URBAN DESIGN

Design Quality Test

DA2017/1274 **1825 Pittwater Road and 52 Cabbage Tree Road, Bayview**
Applicant: Waterbrook Bayview Pty Ltd
 (Site Compatibility Certificate issued to Bayview Golf Club)

Report date: 16th March 2018

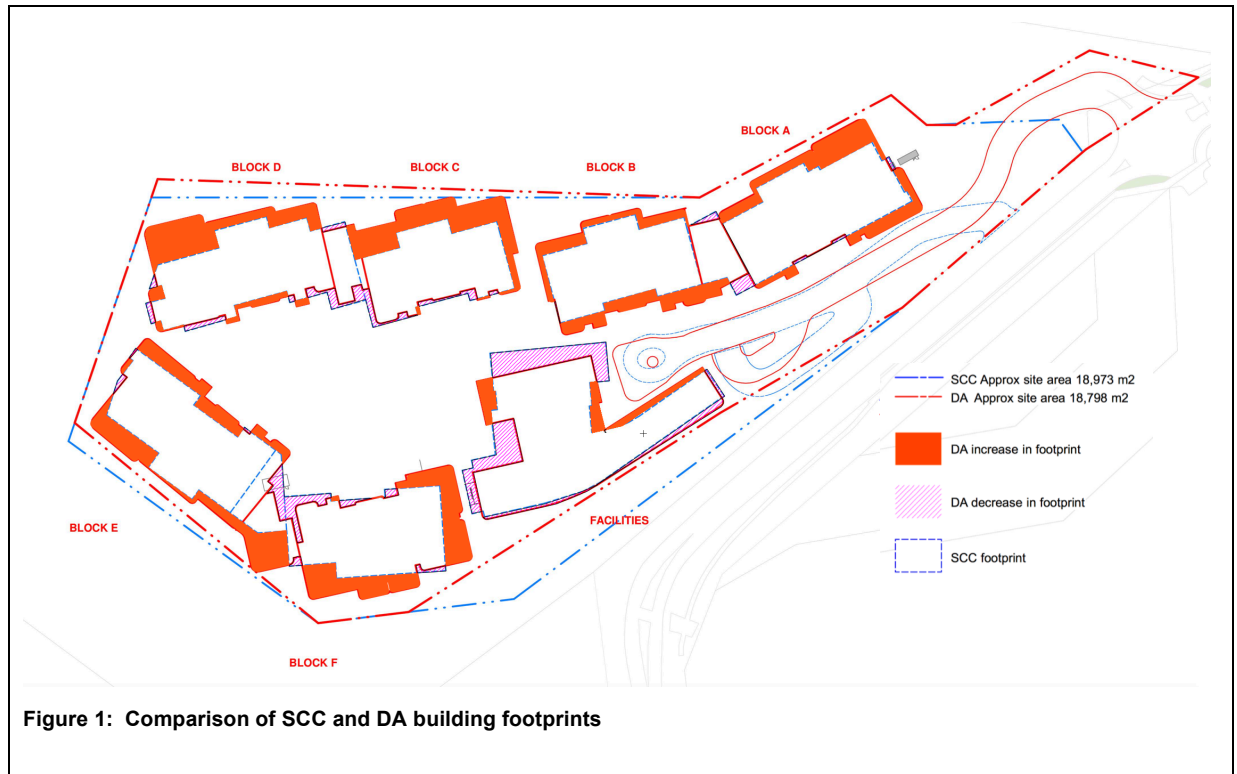
footprints of the SCC and DA documents. Figure 1 below shows the overall increase of the SCC footprints. The orange shaded areas show the additional footprints area added to the SCC approved footprints).

Figure 1 below also indicates the relationship of boundary adjustments and proximity of proposed buildings.

6. **Landscape character – cl 33 (a), (e) of SEPP Seniors** – all screening and softening landscape is proposed to be outside the site boundaries. Proximity of proposed development to site boundaries does not appear to have provided space for canopy landscape within the site as identified in Figure 1 of this report.
